**ZONING AMENDMENT,
PLANNED UNIT DEVELOPMENT &
SUBDIVISION STAFF REPORT****Date: December 5, 2013**

<u>NAME</u>	John Kirby
<u>SUBDIVISION NAME</u>	Kirby Subdivision
<u>LOCATION</u>	7049 Dickens Ferry Road and 7060 & 7068 Airport Boulevard (North side of Airport Boulevard extending to the South side of Dickens Ferry Road, 550'± East of Cody Road)
<u>CITY COUNCIL DISTRICT</u>	District 7
<u>PRESENT ZONING</u>	R-1, Single-Family Residential District
<u>PROPOSED ZONING</u>	B-3, Community Business District
<u>AREA OF PROPERTY</u>	2 Lot / 7.8± Acres (Subdivision) 1 Lot / 4.9± Acres (Planned Unit Development)
<u>CONTEMPLATED USE</u>	Rezoning from R-1, Single-Family Residential District, to B-3, Community Business District, to eliminate split zoning, Planned Unit Development Approval to allow multiple buildings on a single building site and share access between two building sites, and a Subdivision to create one legal lot of record from a single metes-and-bounds parcel. It should be noted, however, that any use permitted in the proposed district would be allowed at this location if the zoning is changed. Furthermore, the Planning Commission may consider zoning classifications other than th

SITE PLAN

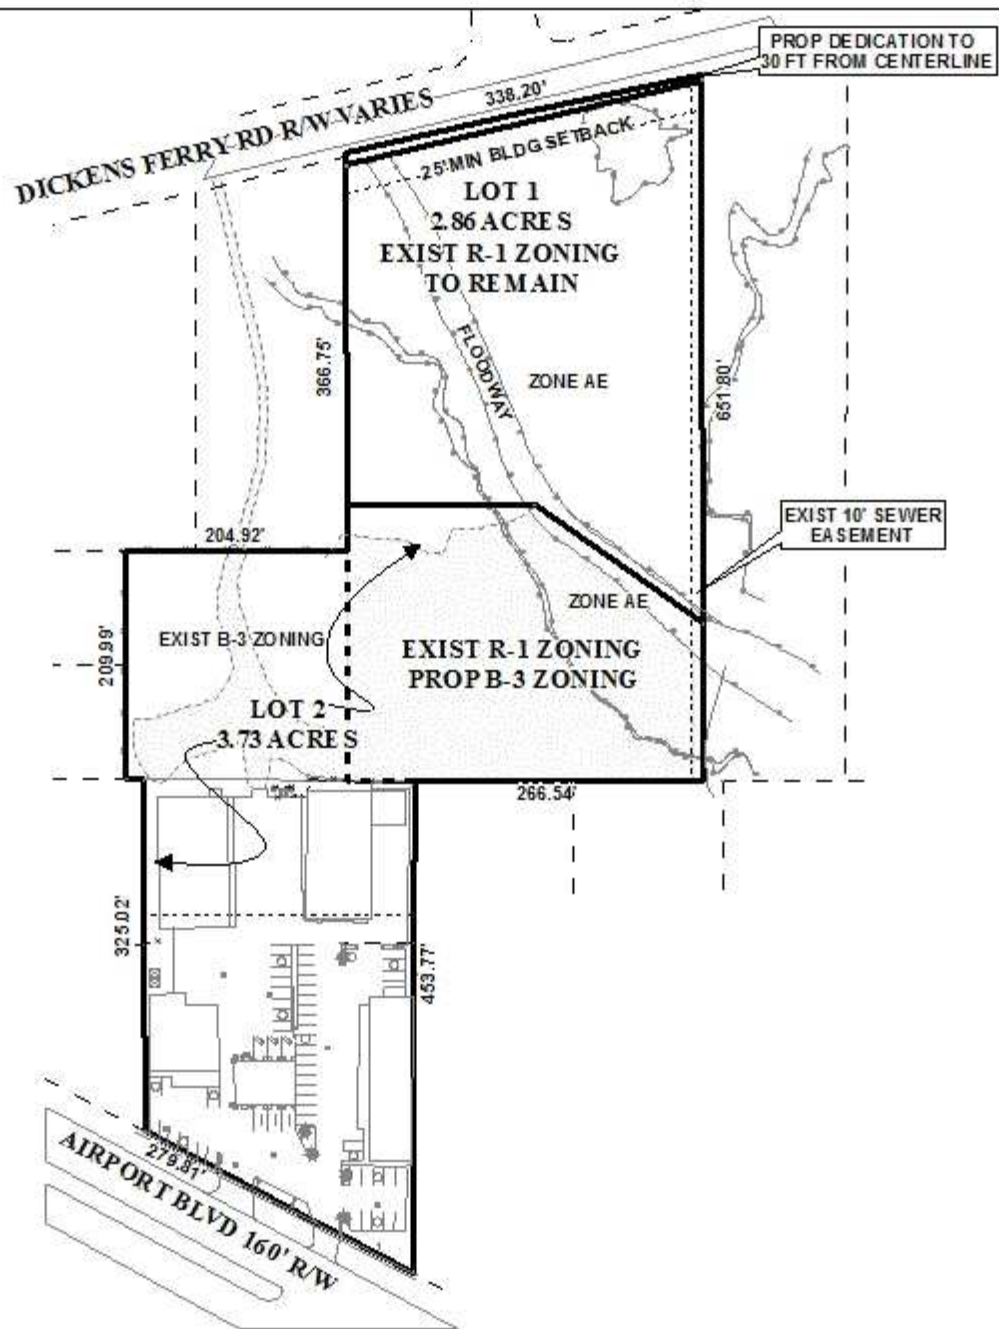
The revised site plan illustrates dedication to provide 30' from the centerline of Dickens Ferry Road as previously requested.

Notes on the revised site plan stating that "The development is denied access to Dickens Ferry Road", and "Lot of 1 of Spectrum Subdivision and Lot 1 of the proposed subdivision are denied access to Dickens Ferry Road. Permitted access to Dickens Ferry will require an approved change to the PUD." These notes should be revised to reflect the revisions to the site plan, as Lot 1 of Spectrum Subdivision is no longer included in the Planned Unit Development, and the proposed Lot 1 is no longer being requested to be rezoned to B-3, Community Business District.

Also, the existing dirt drive access to Dickens Ferry Road is illustrated as being blocked with the provision of a 6' high privacy fence as requested by staff.

The revised site plan provides landscaped area calculations which show that, while the proposed Lot 2 exceeds the total amount a landscaped area required, there is only approximately 20% of the required frontage landscaped area. The revised site plan does illustrate three trees which are 22" or larger in compliance with Urban Forestry comments, and there appear to be five other trees illustrated on the site, however no mention is made of their species or size. It should be noted that the according to Section 64-4E. of the Zoning Ordinance, the site should have a total of 9 frontage trees, 84 perimeter trees, and 3 parking trees.

The revised site plan does illustrate a total of 3 dumpsters, but does not make any mention of any screening in compliance with Section 64-4.D.9. of the Zoning Ordinance.
